Coastal Access – Bamburgh to the Scottish Border (including Holy Island), lengths BBS1, BBS2 and BBS4

November 2020

4. Record of 'full' and 'other' representations and Natural England's comments on them

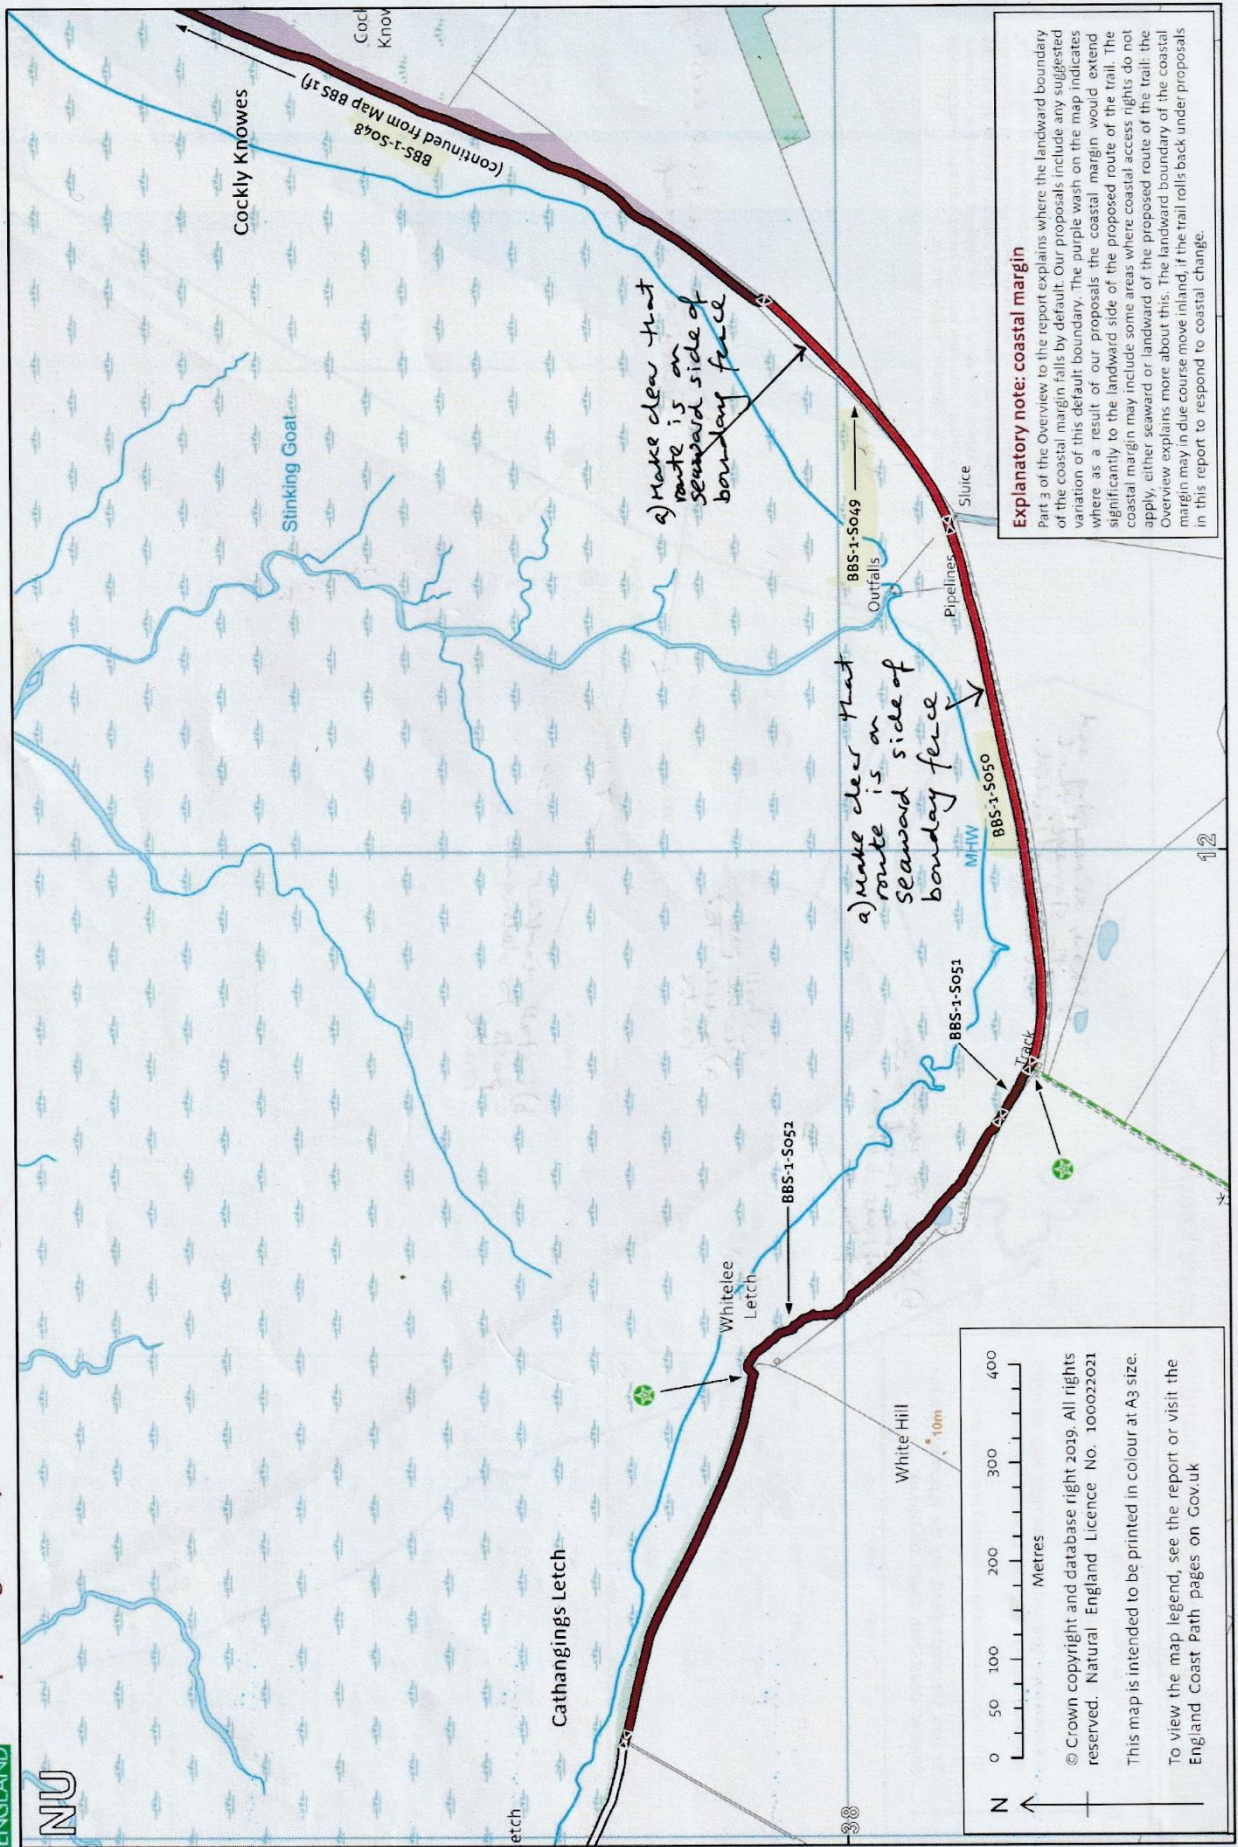
Stretch BBS-1-S046

a) As per General Note 1 on Page 1 of this letter, please show existing fence line on map.

b) Marker posts must be installed, as agreed with [REDACTED] on site in September 2018, defining the actual route through this section.

Stretch BBS-1-S047

a) Continue clear definition of route with marker posts if necessary.

Stretch BBS-1-S048

a) Show, on mapping and with signage, the Old Law excluded

b) Sign to make clear that the route of the path is at the base of the bank.

a) Show, on mapping and with signage, that old haw excluded.

b) Sign to make route follow bottom of bank.

install marker posts a) to delineate route

b) install marker posts to delineate route

a) Please show actual, existing fence line on map

1, Base mapping – Natural England use Ordnance and Survey base mapping data sets for the production of report maps and we are unable to overlay these with other data sets when presenting work to the public. We have been able to use such data sets for internal maps that we have shown to [REDACTED] and his agent, but unfortunately these cannot be used on public facing work.

Map BBS 1d Ross Low Sluice to Ross Back Sands

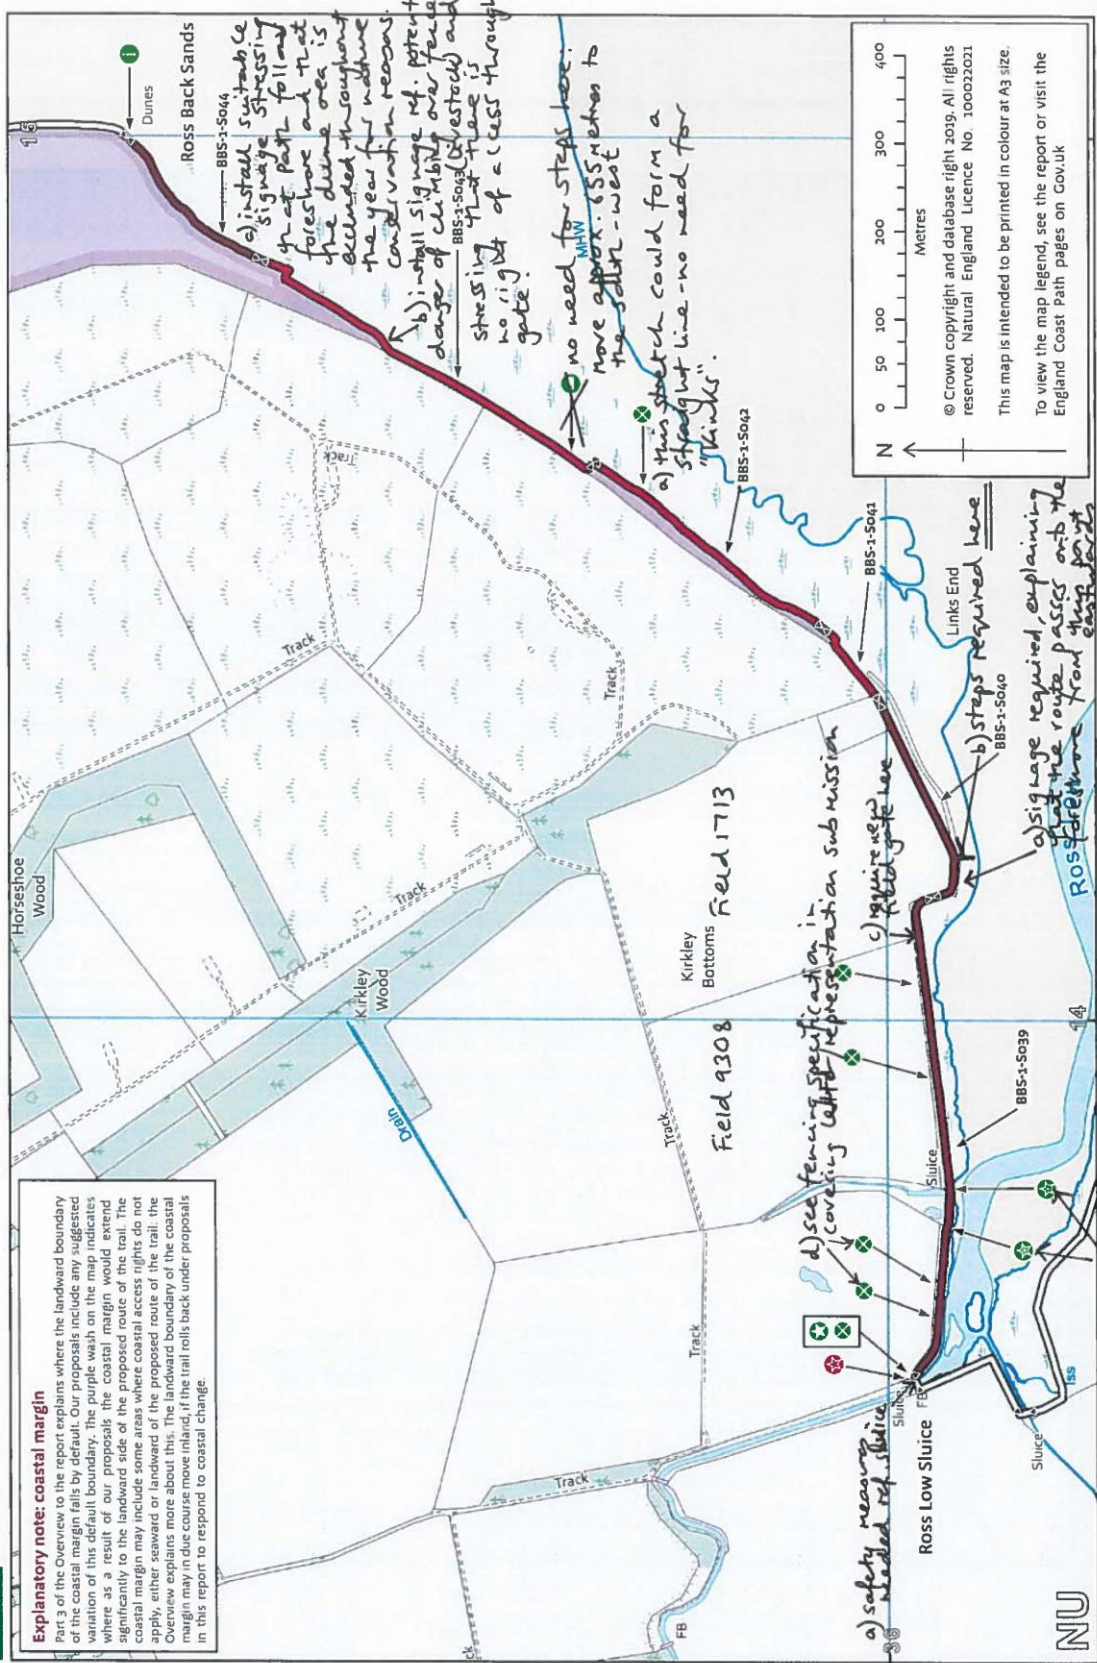
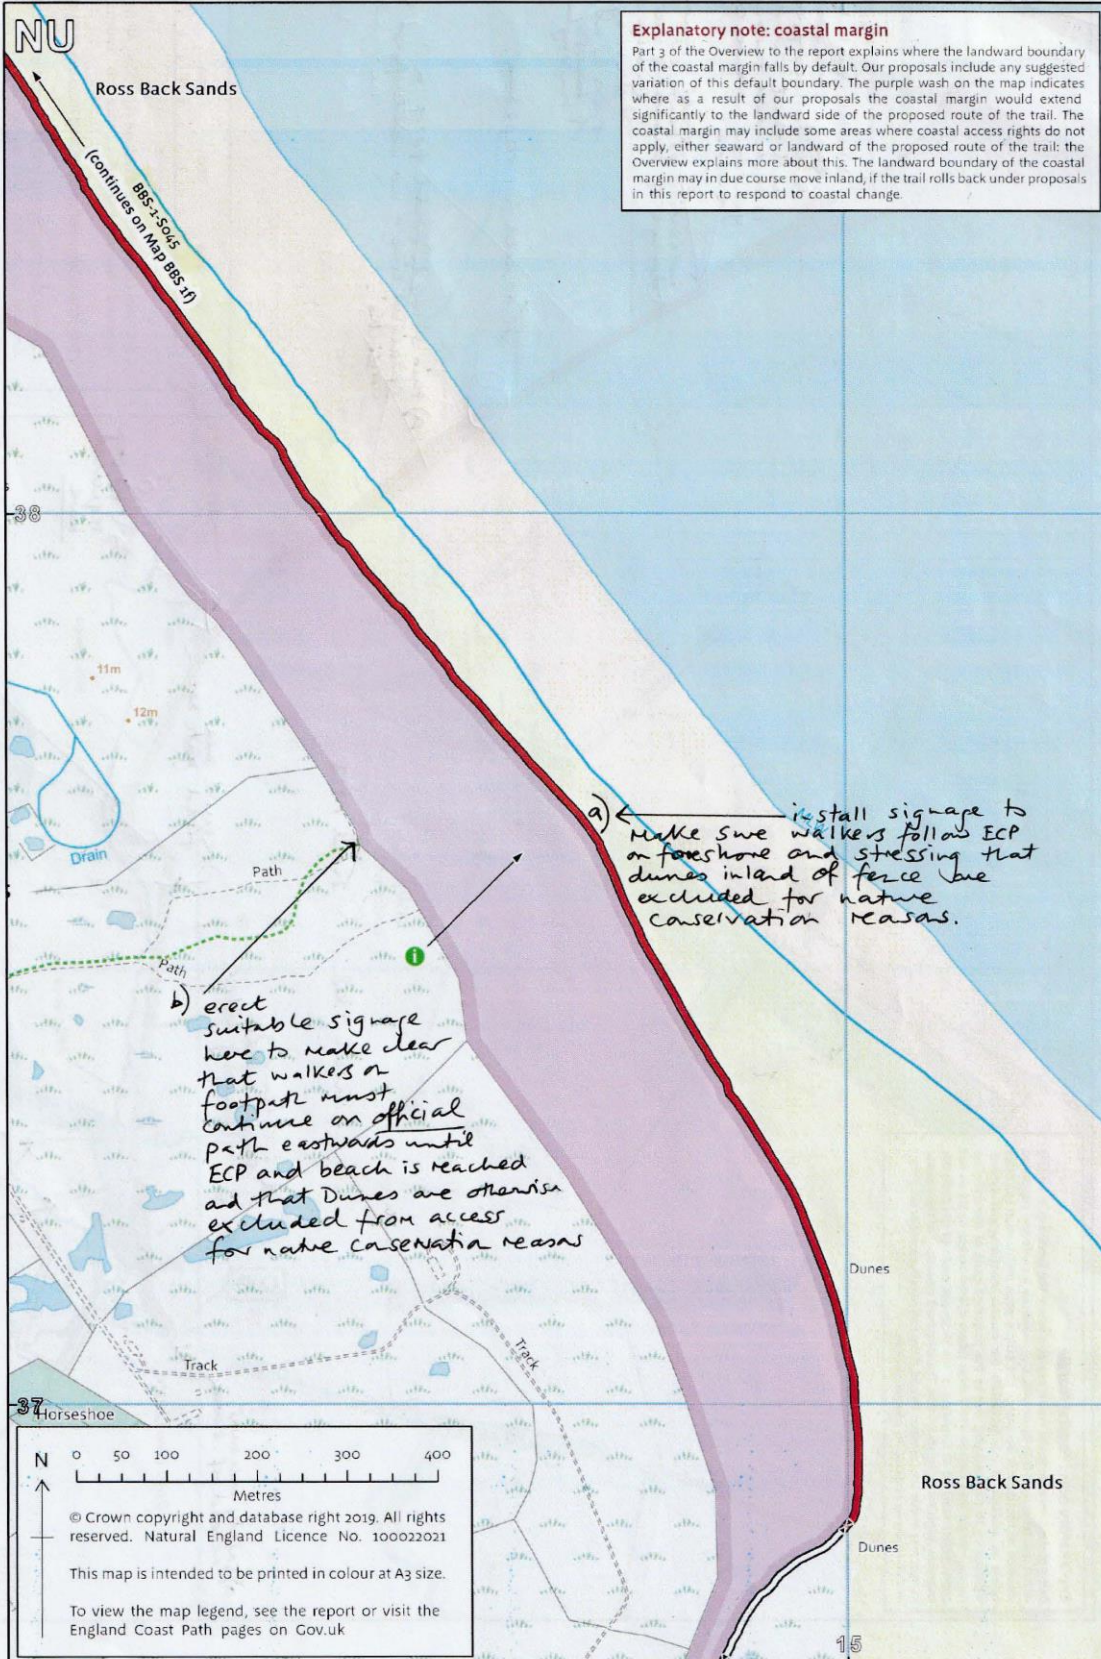
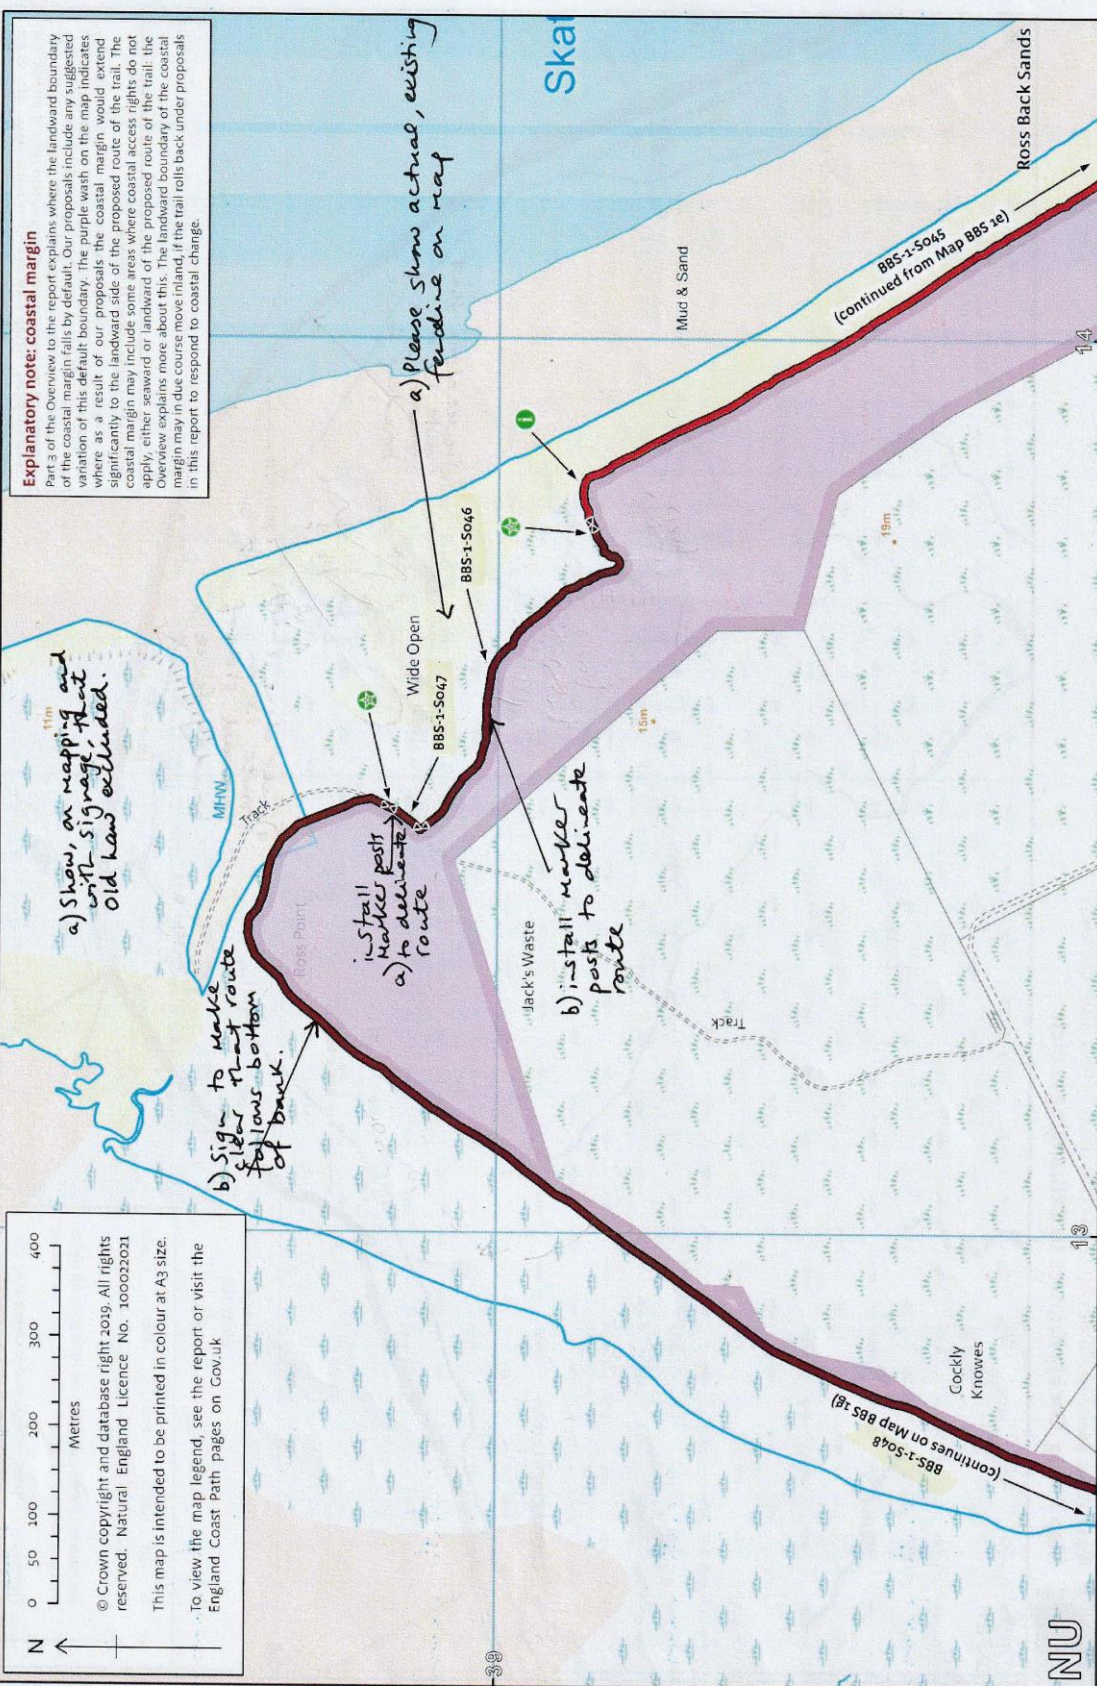
Map BBS1d-Ross Low Sluice to Ross Back Sands

Stretch BBS-1-S039

a) Care will need to be taken where the path crosses the Ross Low flood-control sluice (The Sea Gate). The workings of the flood control and eel gates might well be an invitation to curious people, particularly youngsters, so careful thought should be given to how danger can be minimised.

b) Two field gates to be installed on top of “Sea Wall” (not kissing gates).

c) New field gate to be installed where Sea Wall transects fenceline 9308/1713.

d) Throughout stretch: the fencing specification must be as follows: (using existing fencing where already *in situ*: erecting new where necessary): i) post, pignet and top line wire fence on top of Sea Wall, on seaward side and ii) guard fence on north (landward) side at foot of bank, being post, one intermediate plain wire and one top barb, so as to allow sheep, but not cattle, to pass underneath.

Stretch BBS-1-S040

a) Suitable signage to be erected with map, explaining that the route passes onto the foreshore from this point eastwards.

b) Proposed steps downward onto foreshore should be located where shown, approximately 655m south west of where indicated on plan.

Stretches BBS-1-S042 and BBS-1-S043

a) These stretches could form a straight line – there is no need for a “kink”.

b) Erect signage indicating danger of climbing over fence into fields, and making it clear that there is no public right of access through the gate.

Stretch BBS-1-S044

a) There must be suitable signage explaining about nature conservation and the fact that the path must follow the route shown and that the dune area inland is subject to an exclusion throughout the year, on the grounds of nature conservation matters.

This consultation may result in changing the nature and location of some of the infrastructure specified in the report and on the maps. For example, the location of the steps at section BBS-1-S040, and the type of gate at section BBS-1-S039 are likely to change. We will also ensure that signage on the trail conveys the right information and serves the needs of the landowner and walker alike.

With regard to the sections BBS-1-S042 and S043, there does appear to be a mapping error which Natural England will address.

Map E: Extent of directions - Bamburgh to the Scottish Border (including Holy Island)

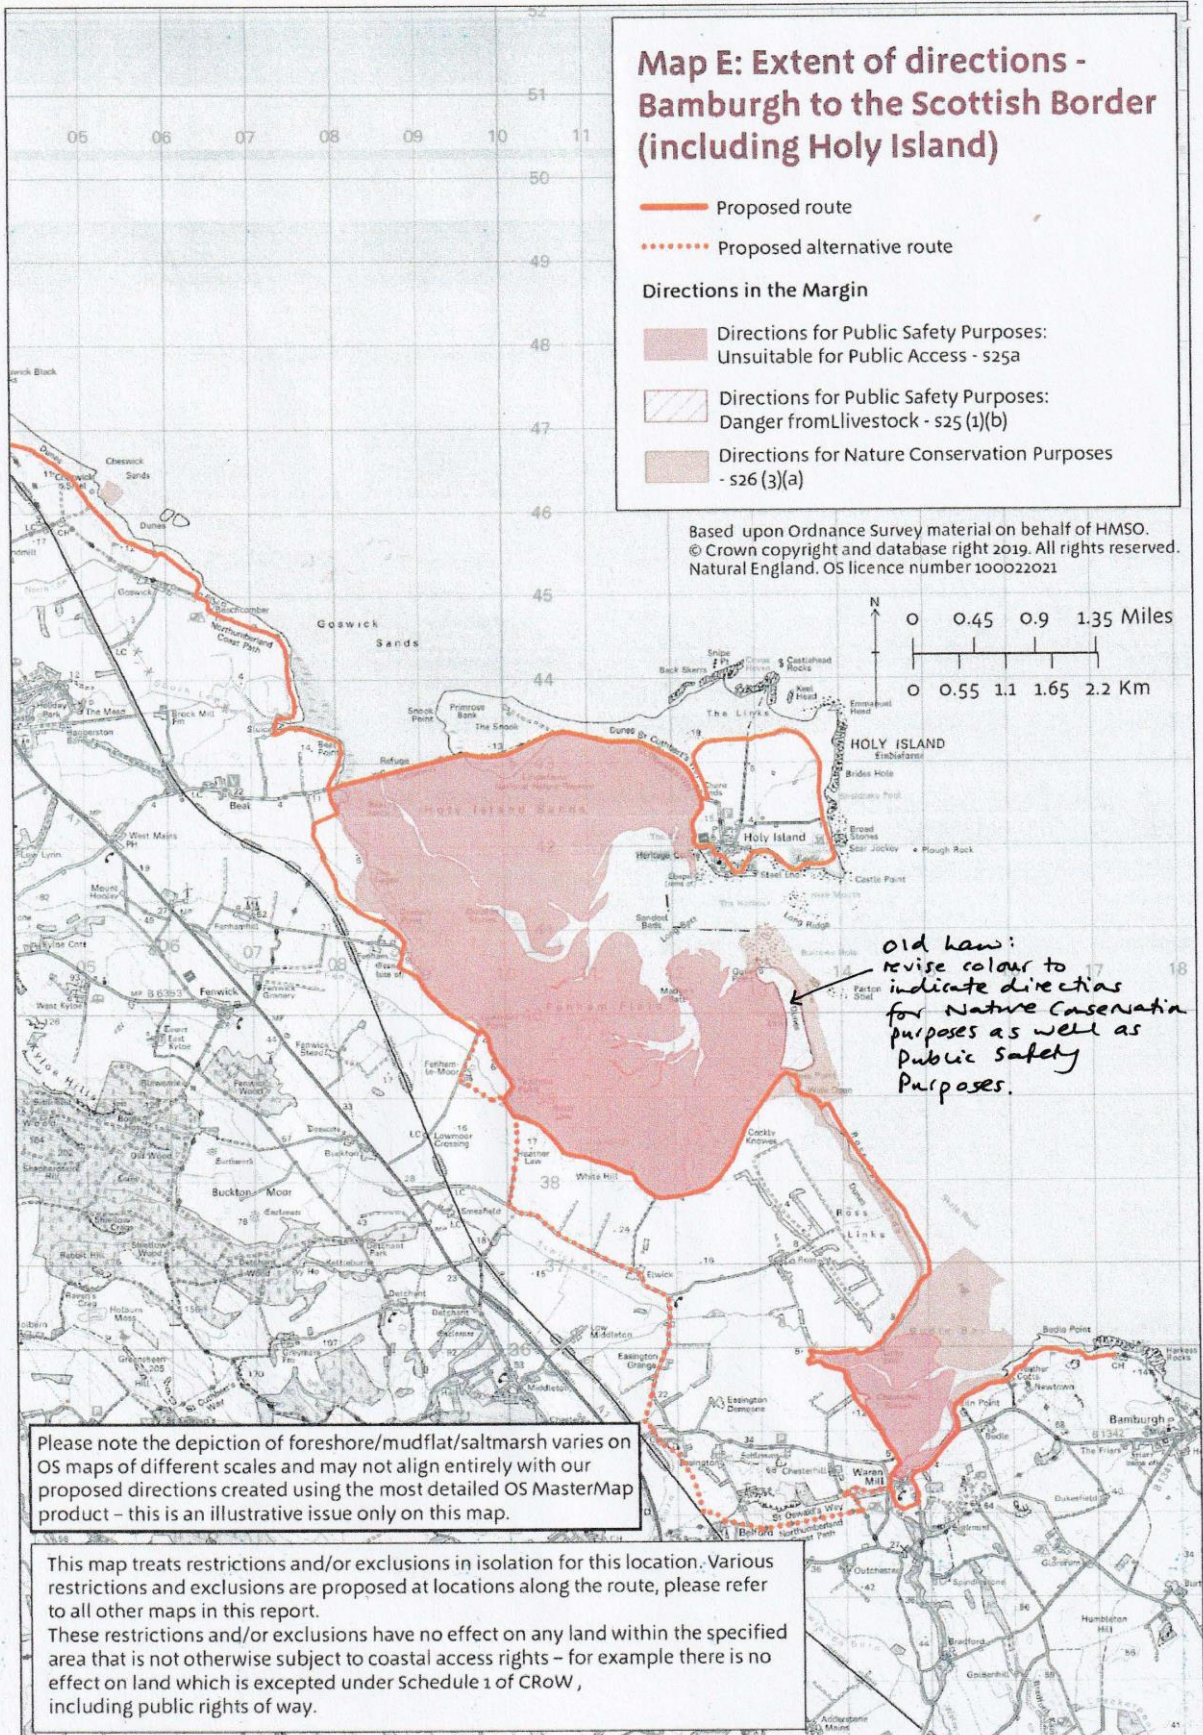
3) **Mapping of The Old Law.** We note from the Overview document (page 30 – rows 2 and 3) that the fenced area known as the Old Law is to be subject to public access exclusions all year round. However, we feel that this should be more clearly shown on the relevant mapping. The exclusion marked on the overview map (Map E on page 32), is shown as being excluded for public safety purposes (danger from livestock), which is stated as being during the period 1st September to 31st March. However, the fact that the area is also to be excluded for the purposes of nature conservation (sensitive wildlife) from 1st April to 31st August each year is not made clear.

Consequently, the relevant wash colour should extend over the entirety of the Old Law on Map E. Furthermore, the fact that exclusions will be year-round on Old Law should be made clear on the detailed mapping. At present, the full extent of the Old Law is not even shown on the detailed mapping at all.

*old law:
revise colour to
indicate directions
for Nature Conservatⁿ
purposes as well as
Public Safety
Purposes.*

3, Mapping of Old Law – All directions to restrict or exclude access are listed on the [Open Access Website](#) It will also be covered on the ground through interpretation at key points. The area known as Old Law has a direction on it for the period of 1st September to 31st March only. Outside this time of year the area around Old Law is restricted for a nature conservation reason which isolates Old Law from being accessible. Therefore effectively the area known as Old Law is restricted all year round.
